Analysis of Appalachian's Proposal for Water Management

William Brush
Smith Mountain Lake Association
Tri-County Relicensing Committee

Presented to RRBAC
15 April 2008

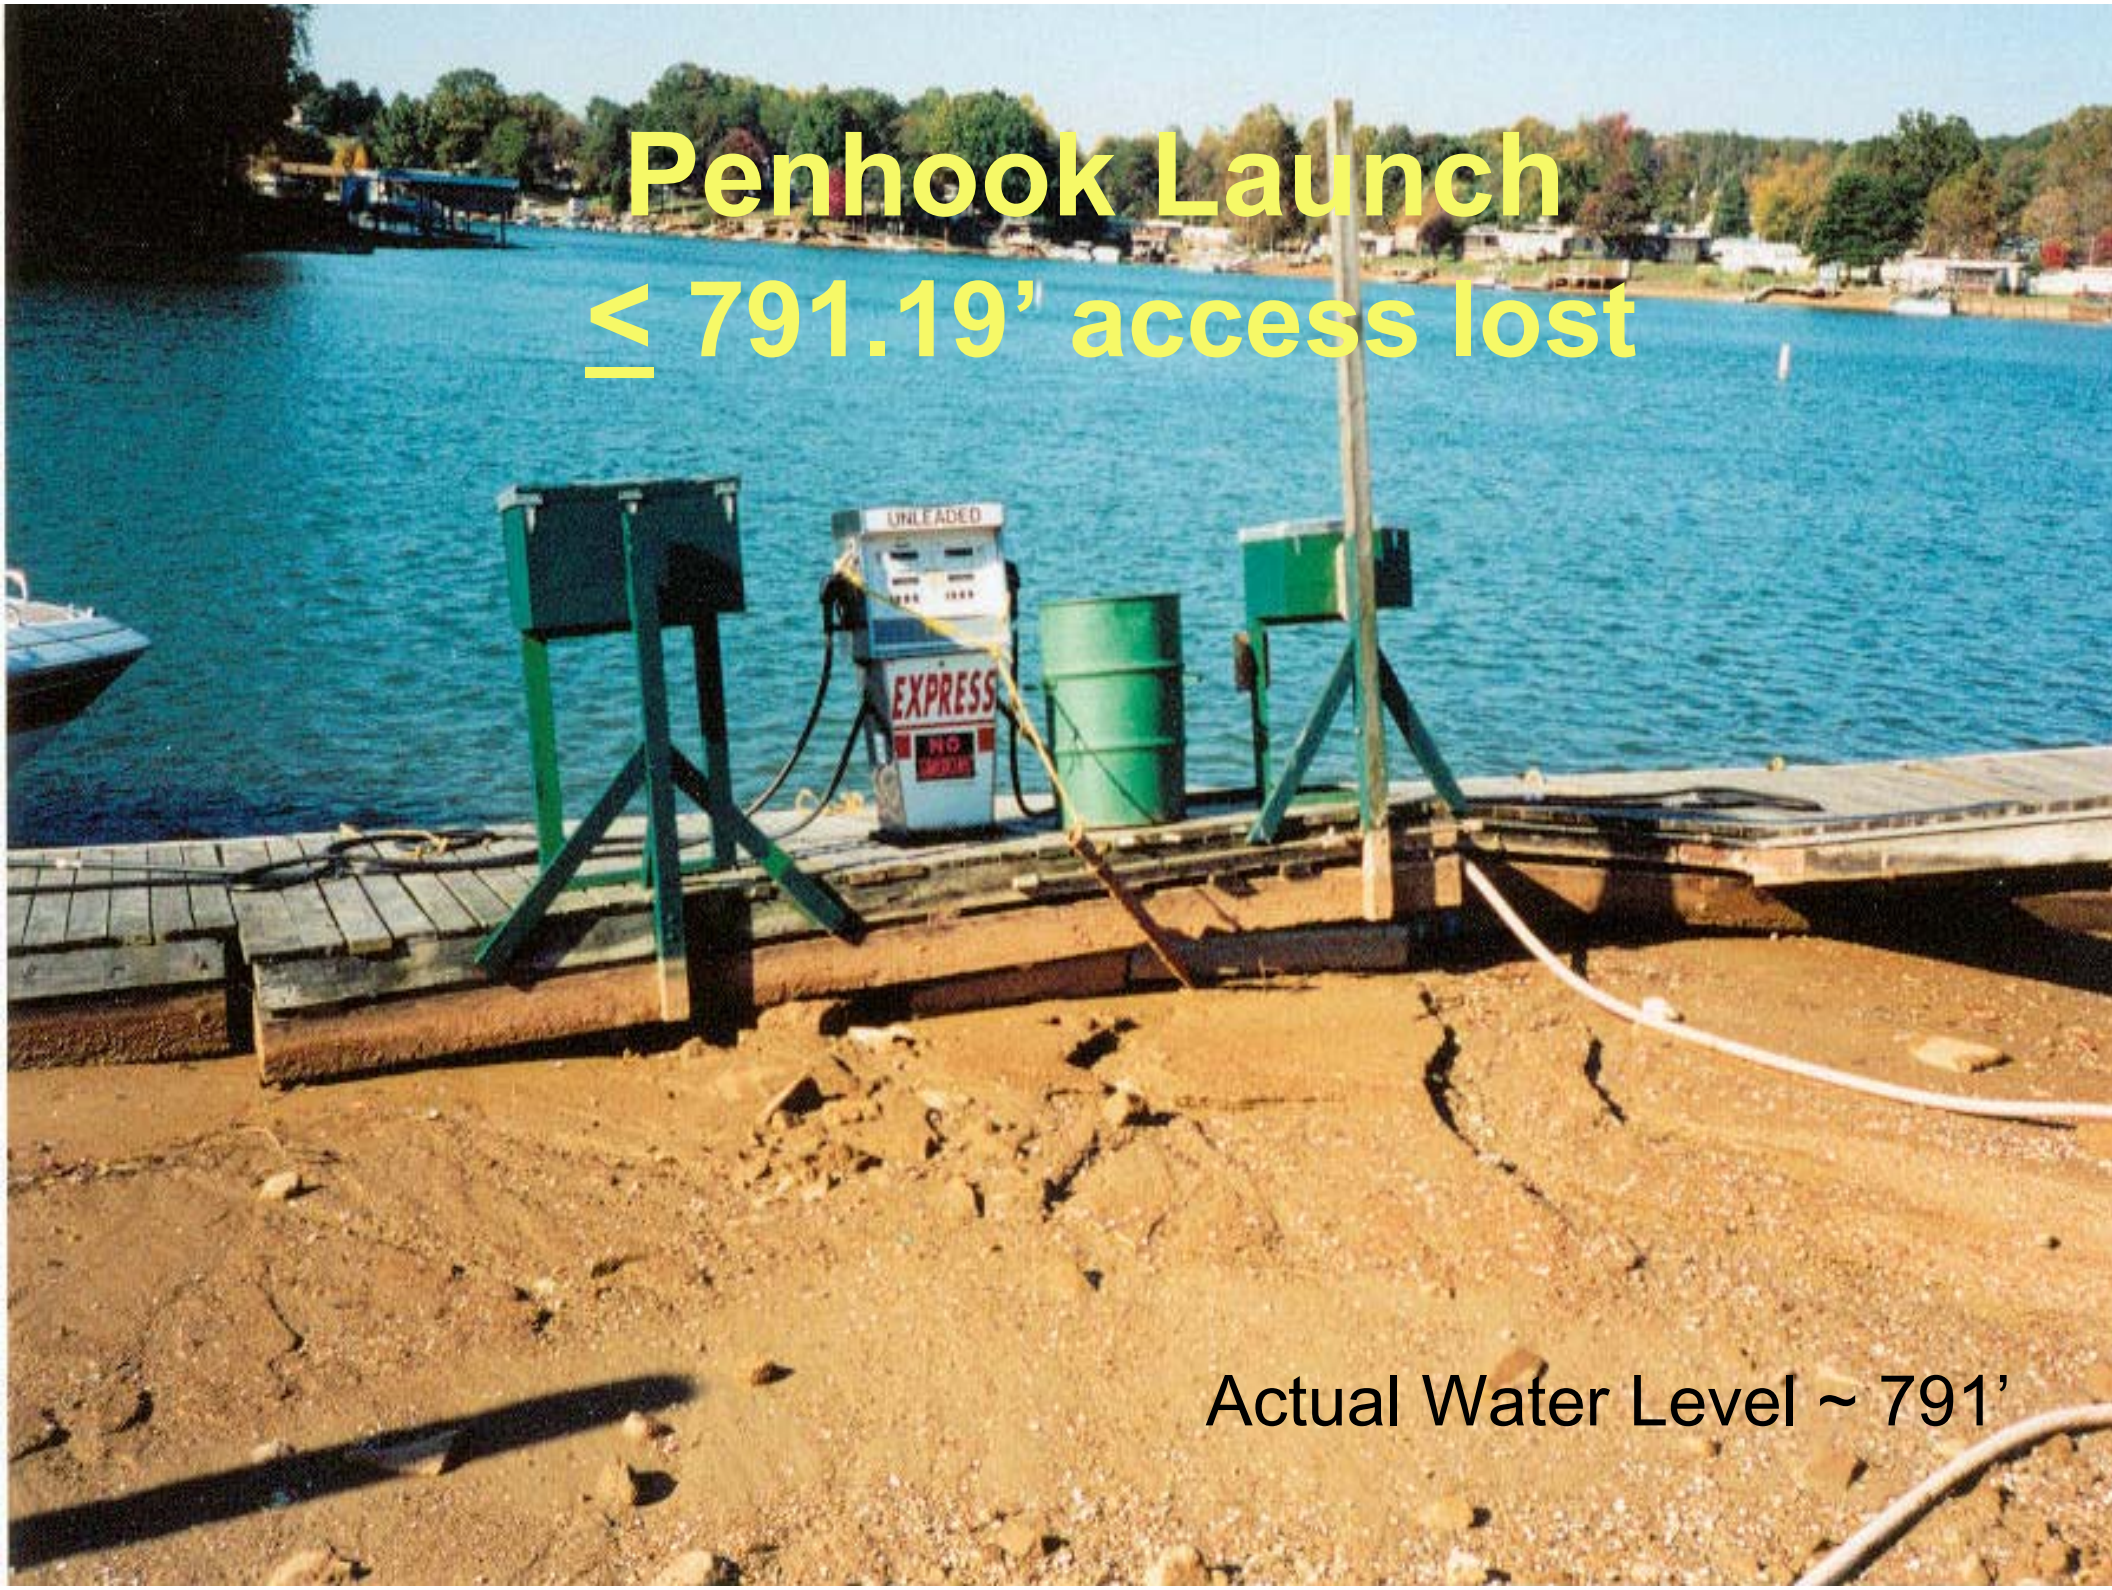
Penhook Launch
≤ 791.19’ access lost
UNLEADED
EXPRESS
Actual Water Level ~ 791’

Hardy Ford Access
≤ 790.48’ access lost
Actual Water Level ~ 790.5’

SML Recreation Season Impacts

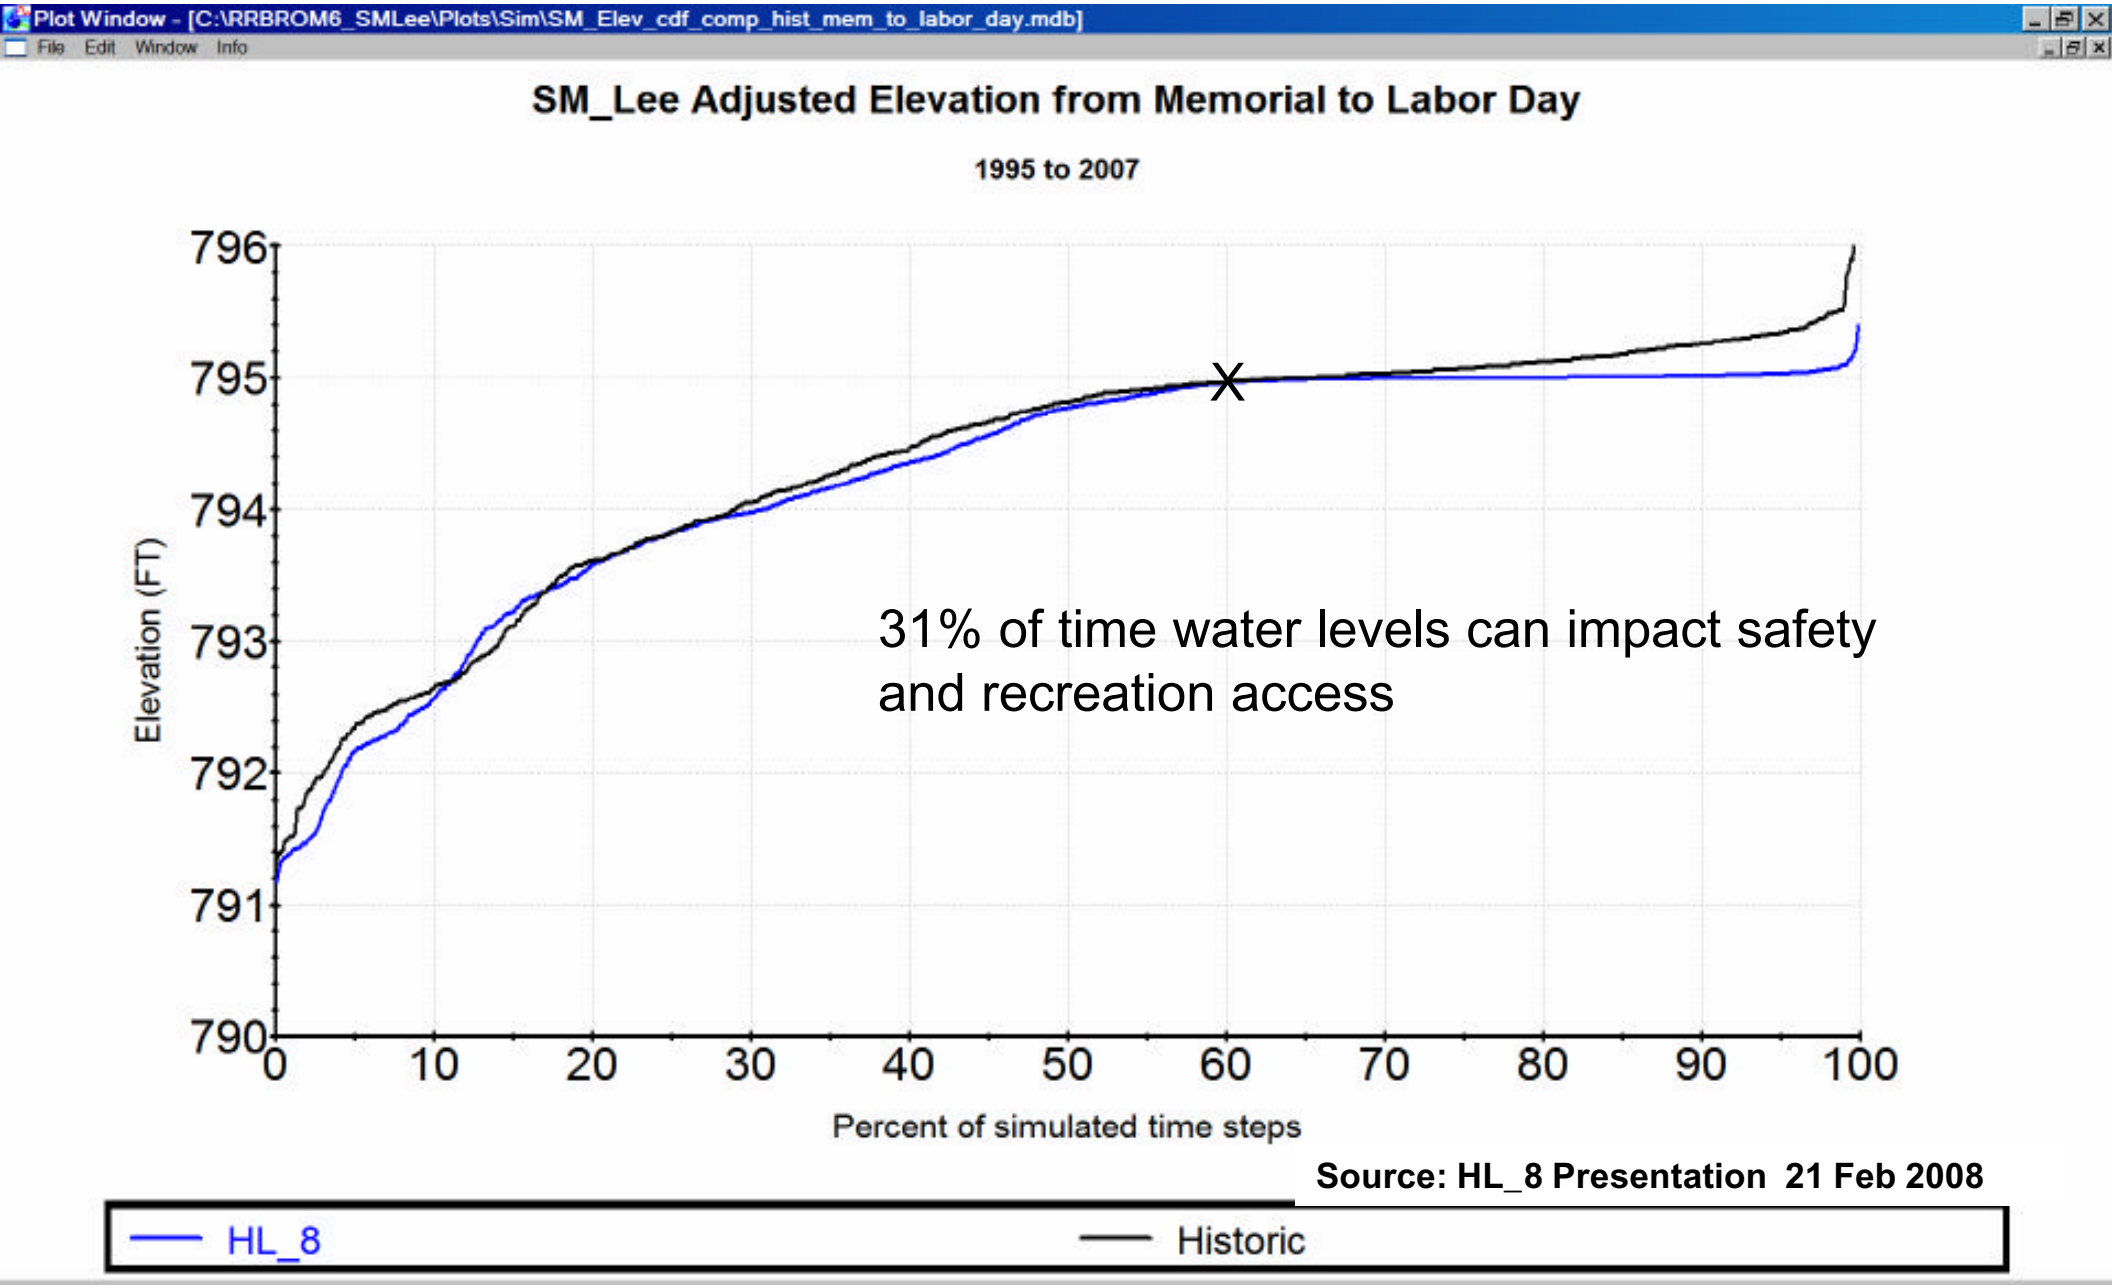
HL-8 vs. Natural Hydrograph @ Brookneal

50% Pt.	Augment	Aligns	Recharge
Jan	2,100	18%	57%	25%
Feb	2,550	13%	20%	67%
Mar	2,650	1%	4%	95%
Apr	2,500	0%	85%	15%
May	2,000	65%	25%	10%
Jun	1,450	65%	27%	8%
Jul	1,100	80%	20%	0%
Aug	850	85%	10%	5%
Sep	750	70%	15%	15%
Oct	850	60%	25%	15%
Nov	1,100	25%	65%	10%
Dec	1,600	25%	67%	8%
